# Duquesne Light Company

Reference: Beaver Valley Power Station, Unit No. 1  
Docket No. 50-334, License No. DPR-66  
Responses to R. G. 1.97 Evaluations

## ATTACHMENT 1

### Steam Generator Wide Range Level Instrumentation

Figure 1

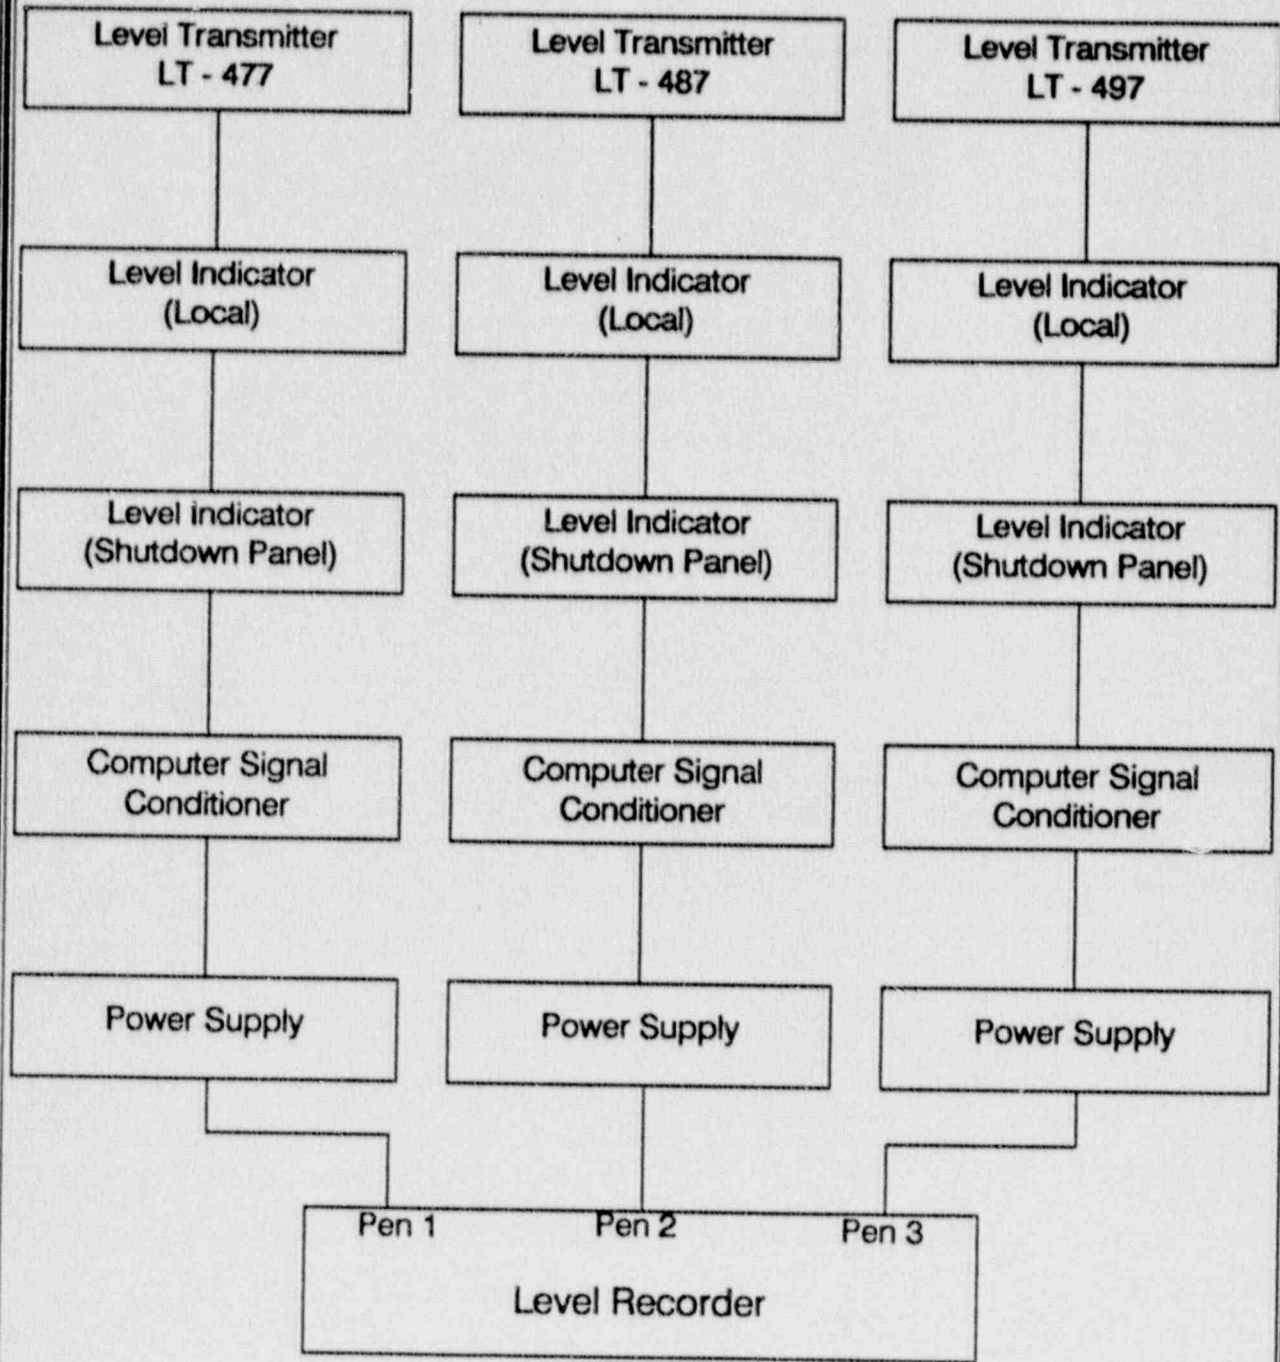
The three wide range steam generator level channels are indicated and recorded on a single recorder. A failure of the power supply to the recorder would result in a loss of three wide range level indications.

The three wide range level channels are powered from separate vital busses but are routed together in neutral cable trays from the sensors to the indicating and recording device. No isolation devices are installed. Regulatory Guide 1.97 describes steam generator level as a D1 variable.

Therefore, we are proposing the following resolutions to the SGWR level instrumentation deviation. Based on the above and the additional information provided in our responses of December 18 and 21, 1989, we believe that the existing configuration of the instrumentation and the design of the auxiliary feedwater system is adequate to monitor the steam generator levels and to ensure an adequate supply of auxiliary feedwater to the steam generators. Consequently, we are requesting that the NRC review this information and consider accepting the deviation on the merits of the existing design. If the review results are favorable, the SGWR level will be changed to a D2 variable for the BVPS-1.

Figure 2

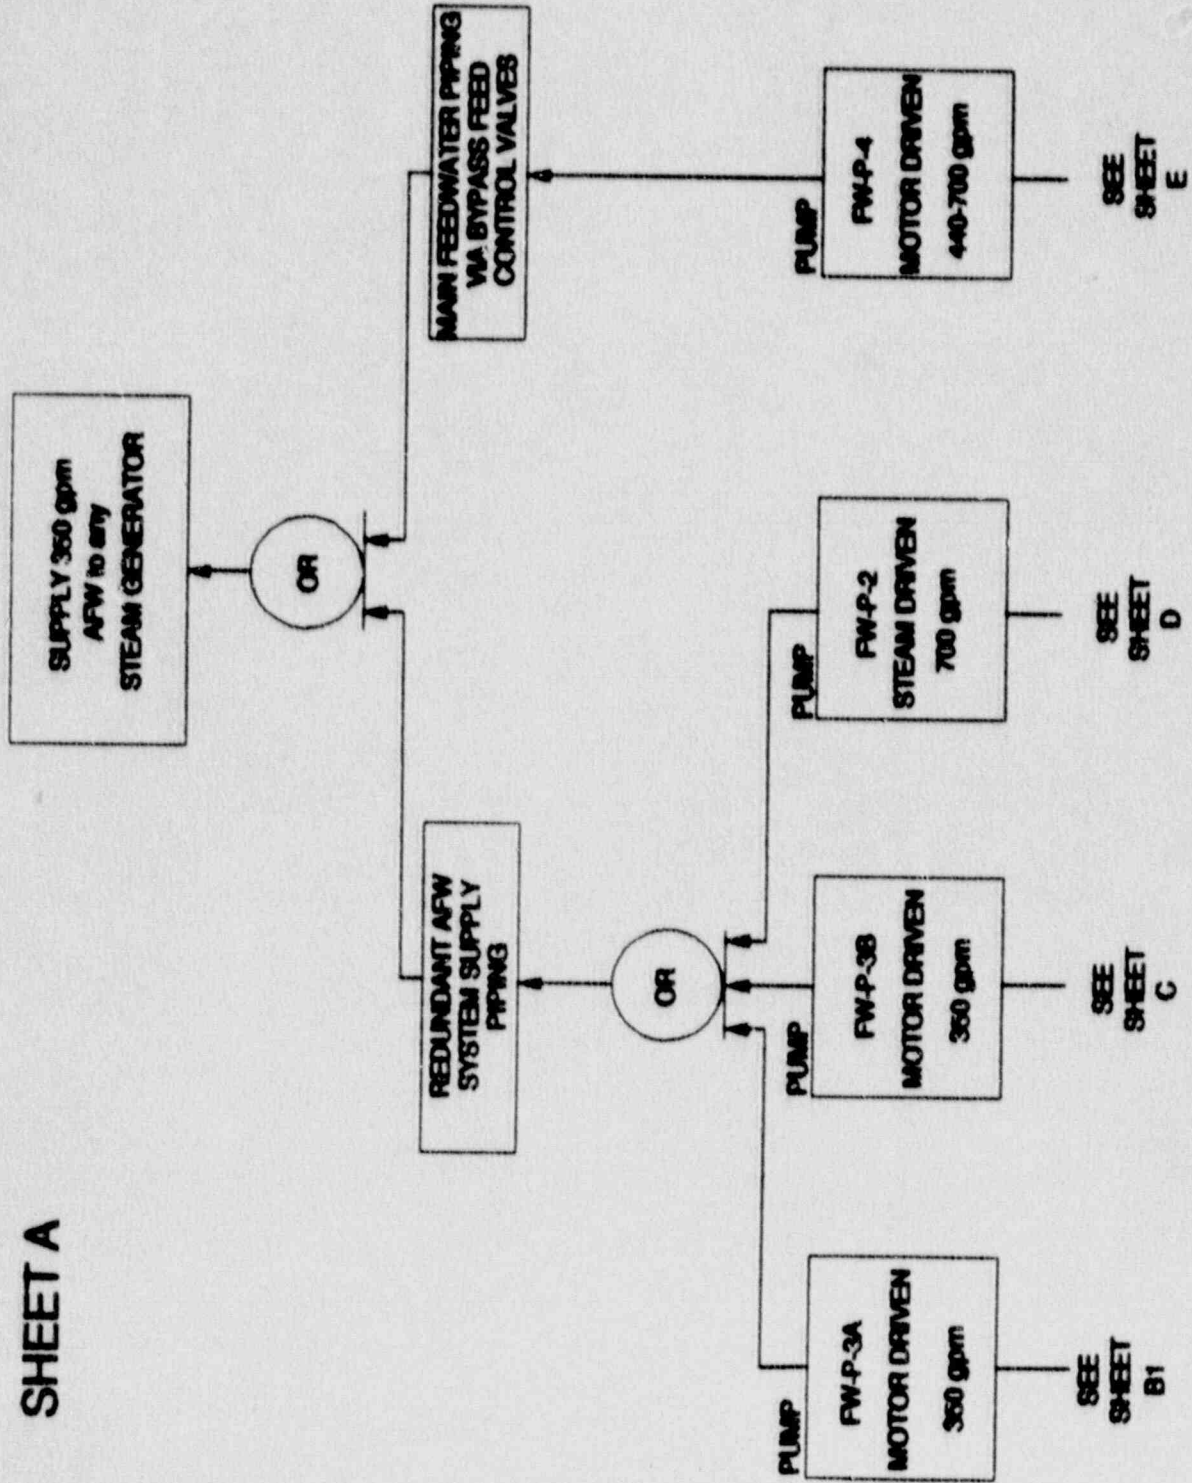
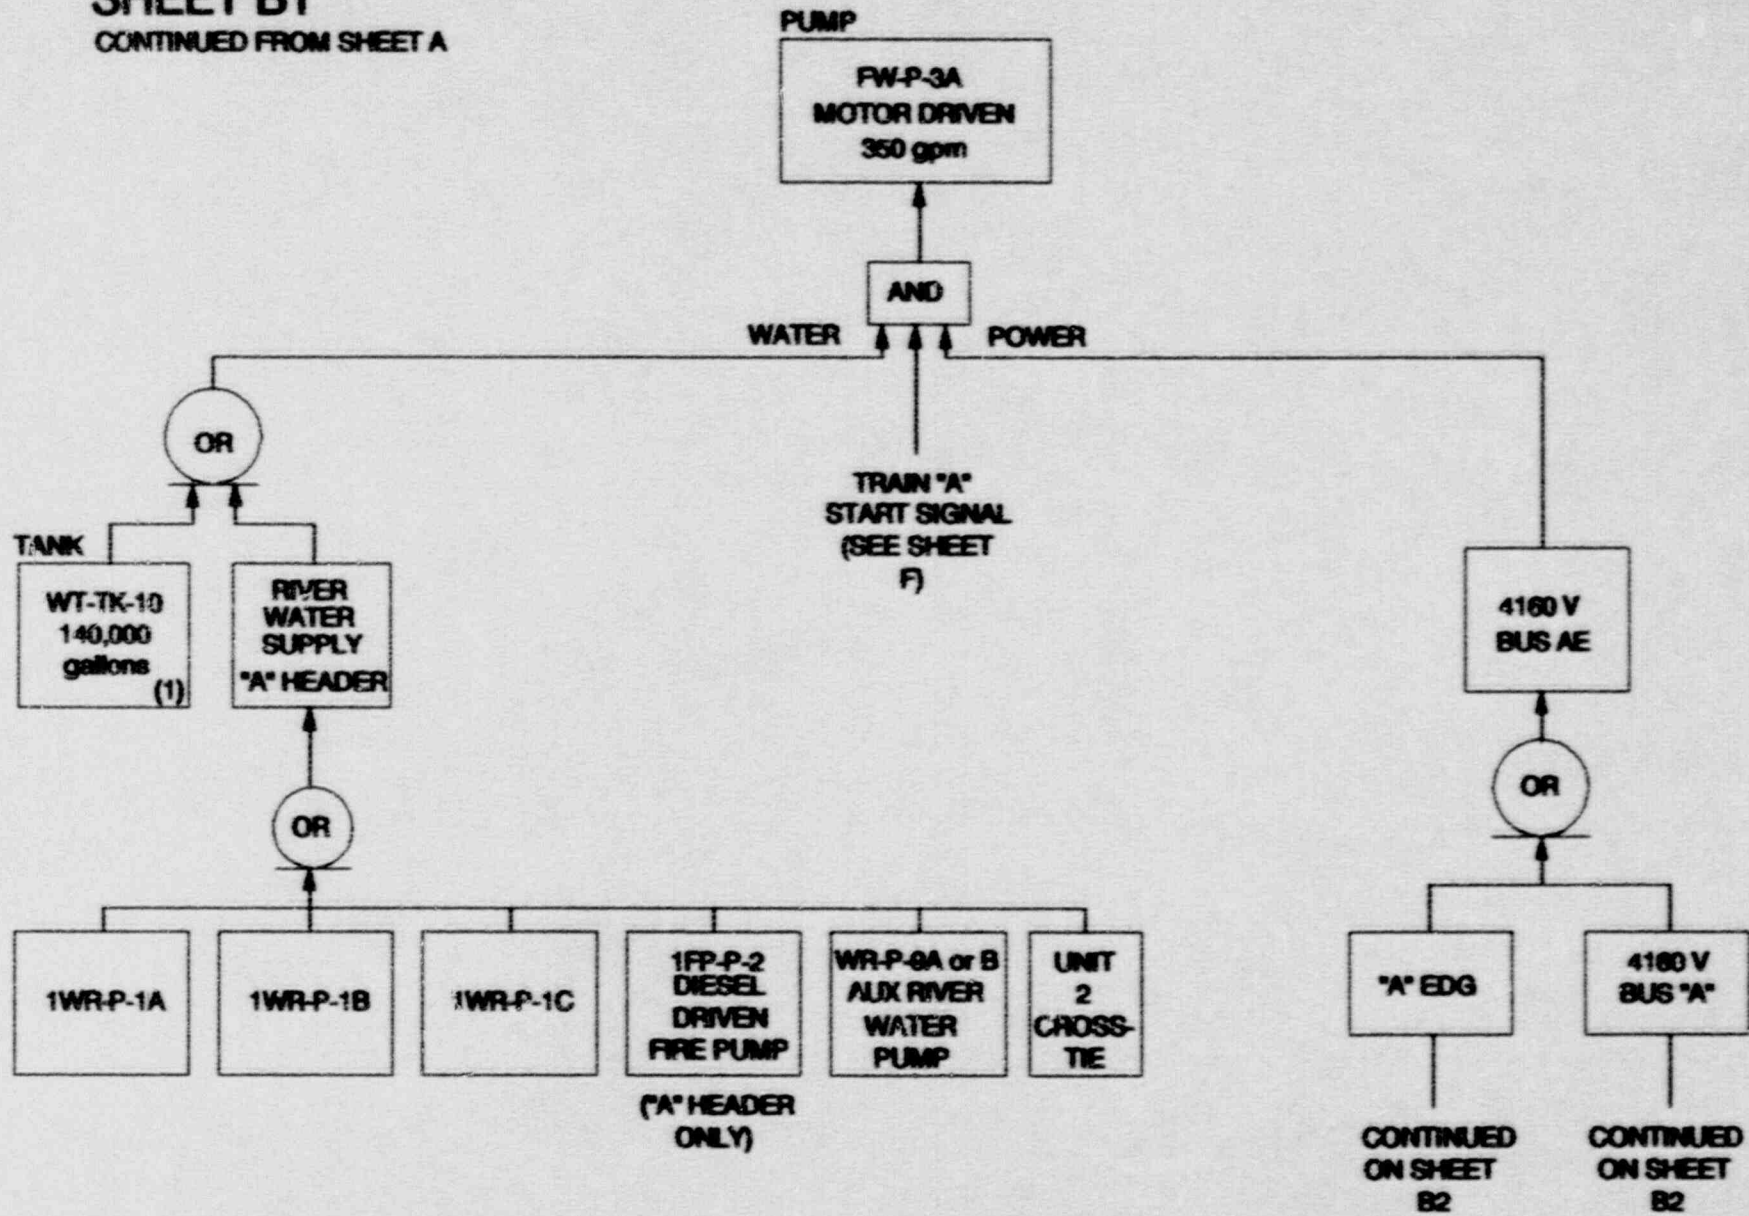
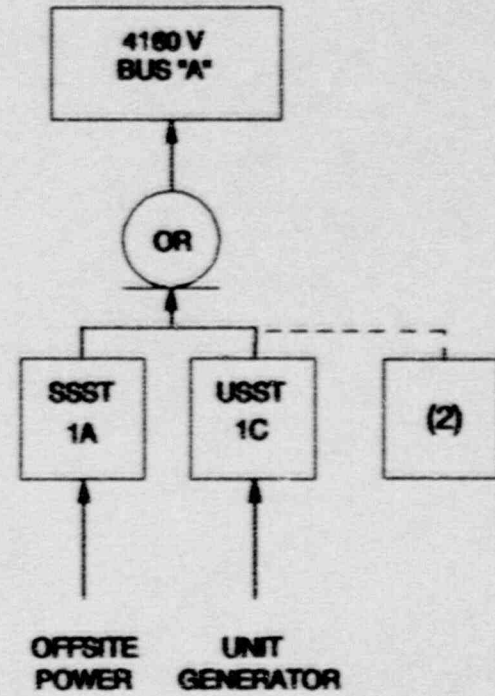
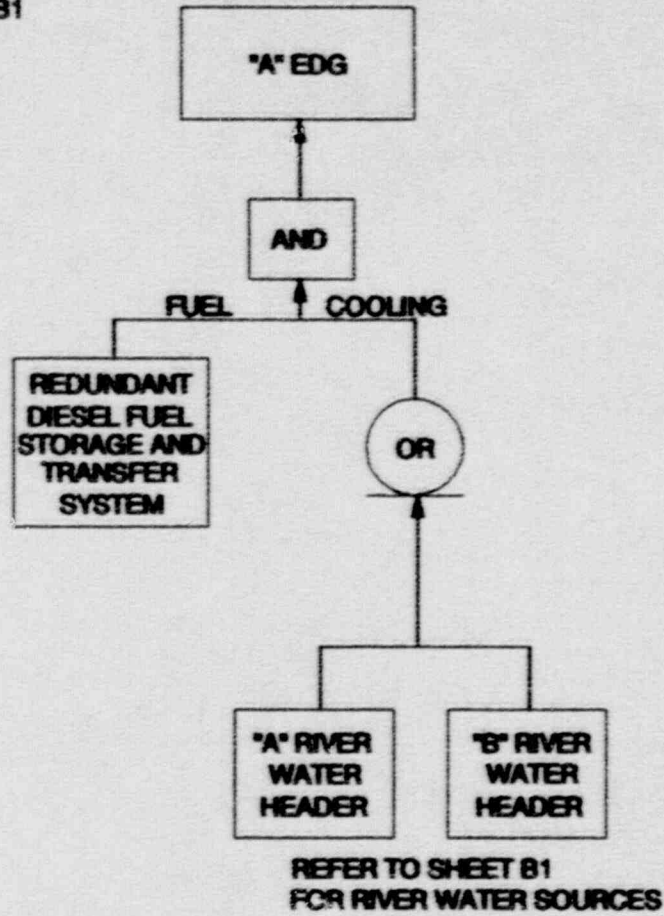
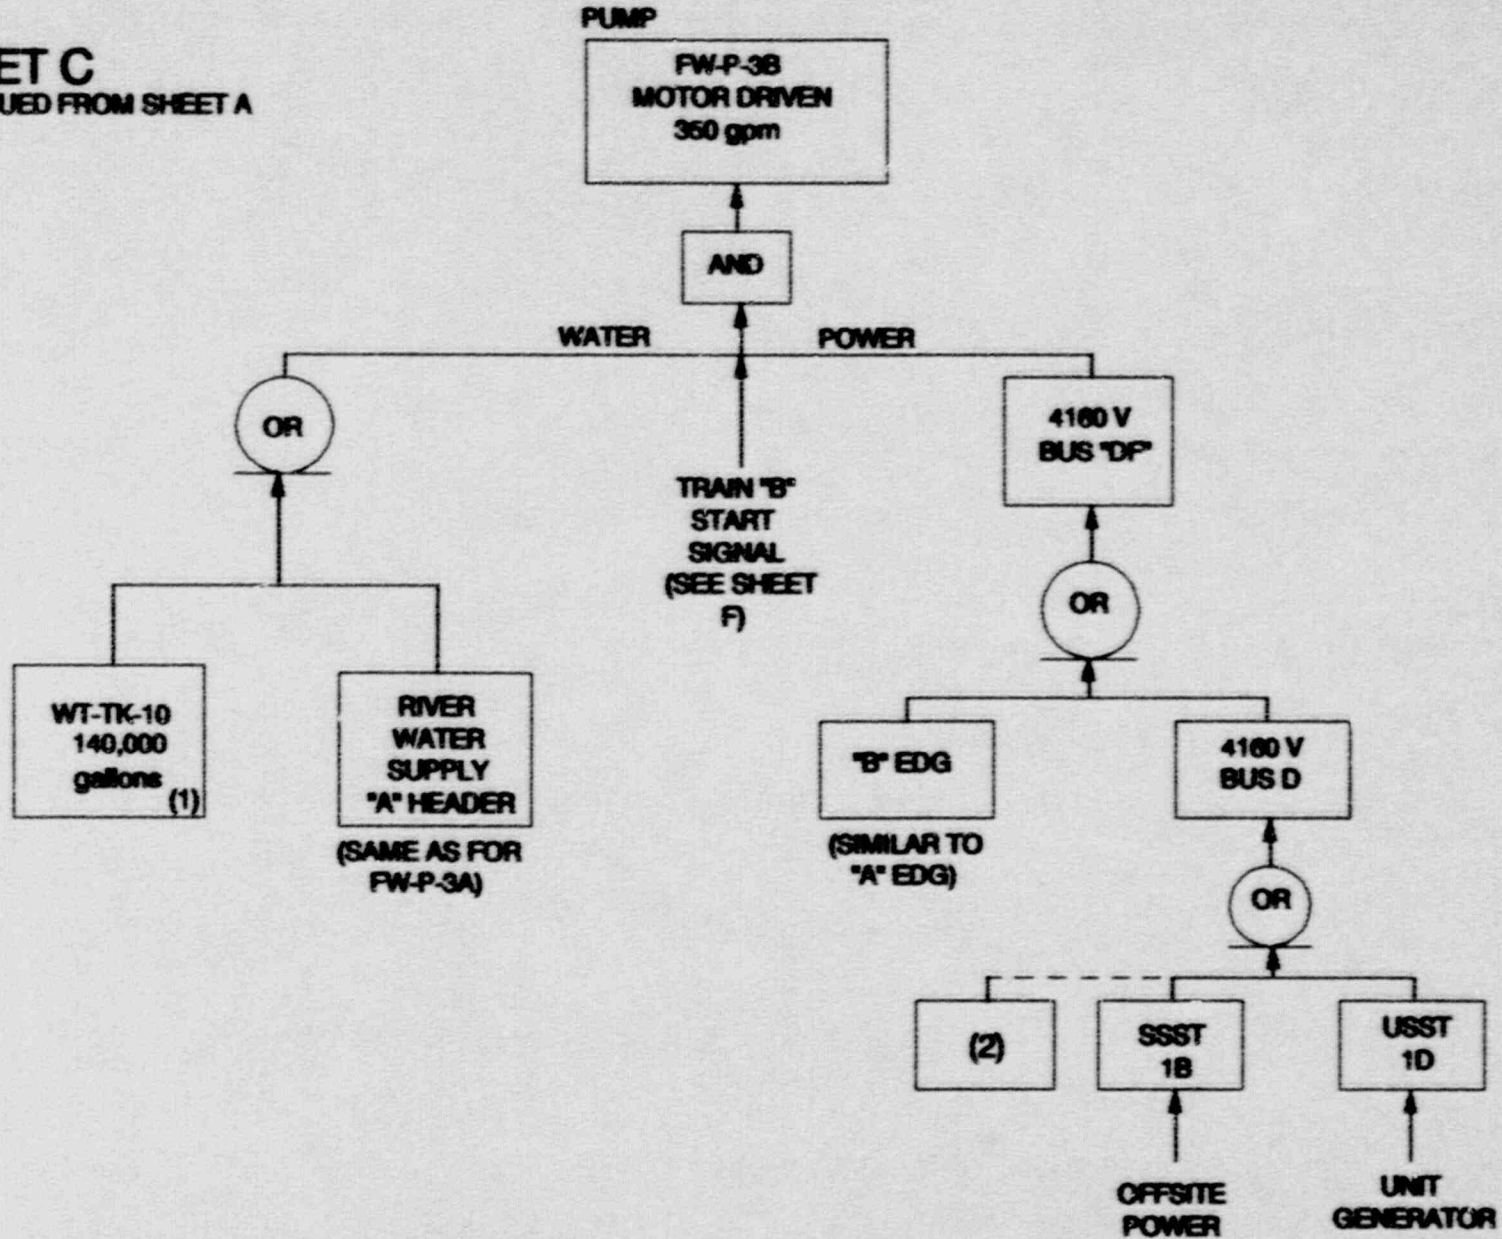
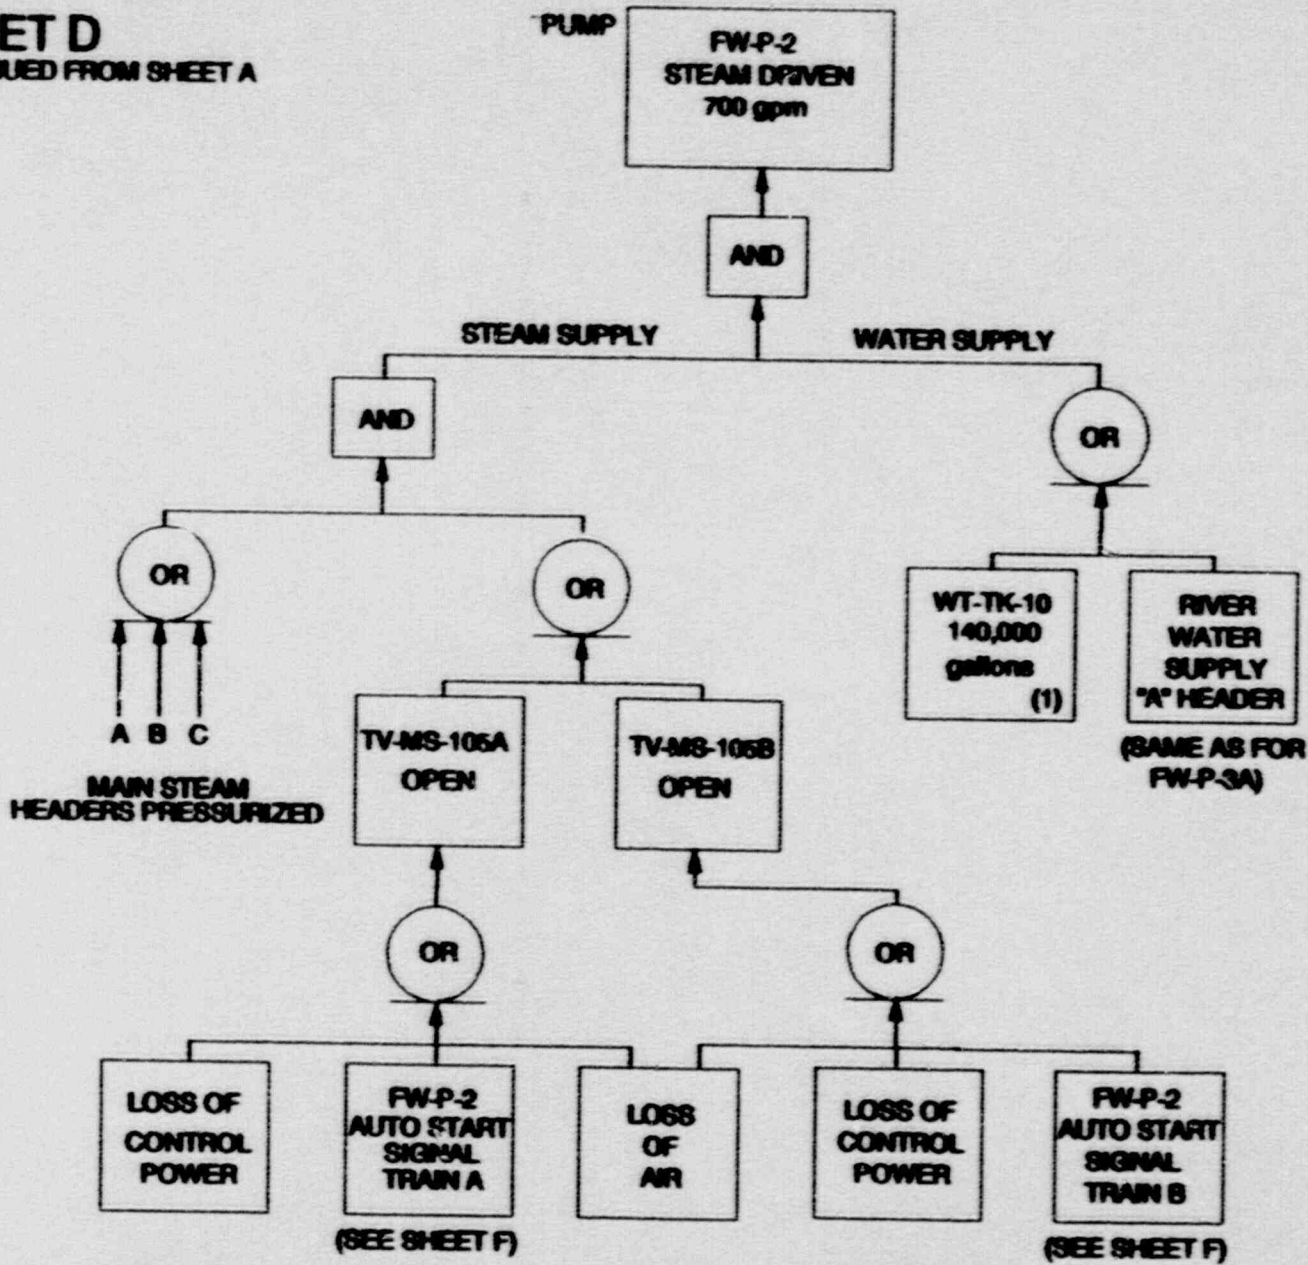
Figure 2 to this attachment provides the logic model which we developed to show that the procedures are supported by the BVPS-1 design. The figure shows that additional systems are available to mitigate conditions leading to steam generator dryout. The logic model shows several success paths for supplying 350 gpm of auxiliary feedwater to any steam generator. The system is supplemented by an additional auxiliary feedwater pump, FW-P-4, which was included to satisfy Appendix R. The 4160V electrical supply for the auxiliary feedwater system will have another power source added for Station Blackout. The model also shows the redundancy of the river water supplies.
